Appn: 4/25/2349/0R1
Site Address: LAND AT HARASS MOOR, WHITEHAVEN
Proposal: APPLICATION FOR APPROVAL OF RESERVED MATTERS RELATING TO APPEARANCE, LAYOUT, LANDSCAPING AND SCALE FOR THE ERECTION OF 300 DWELLINGS WITH ASSOCIATED OPEN SPACE & INFRASTRUCTURE PURSUANT TO OUTLINE PLANNING APPROVAL 4/18/2287/001 (THE OUTLINE WAS NOT AN EIA APPLICATION)

Outstanding Matters - Harass Moor Reserved Matters Application

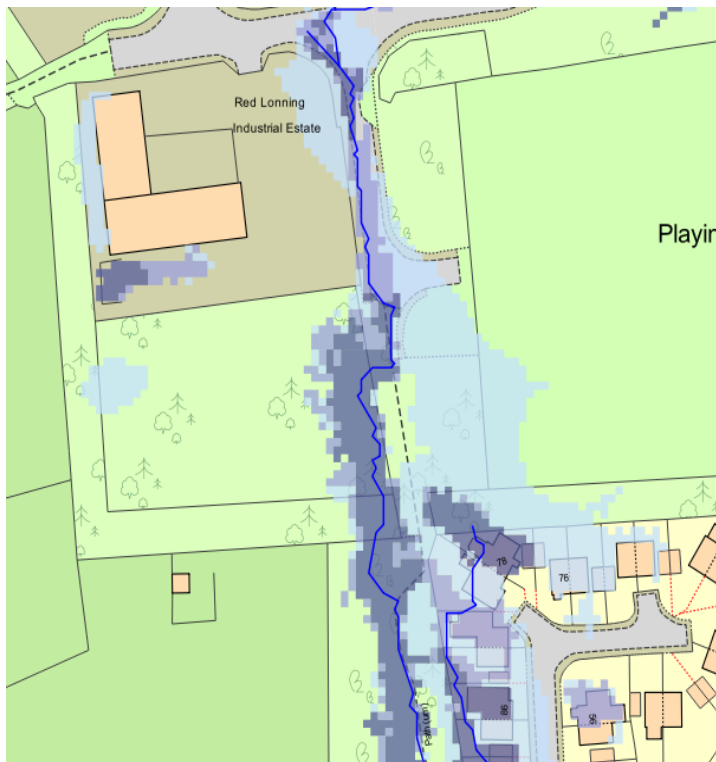
- *The need for cut-off drains or filter drains along the western boundary above existing residential properties;*

This matter has not been addressed. Filter drains (with swale if necessary), should be explored for the SW boundary adjacent to Highgrove. The risk from overland flows in these areas should be considered in conjunction with the exceedance flows from the attenuation basins. More information is needed to demonstrate there is no overland flow risk to downstream properties.
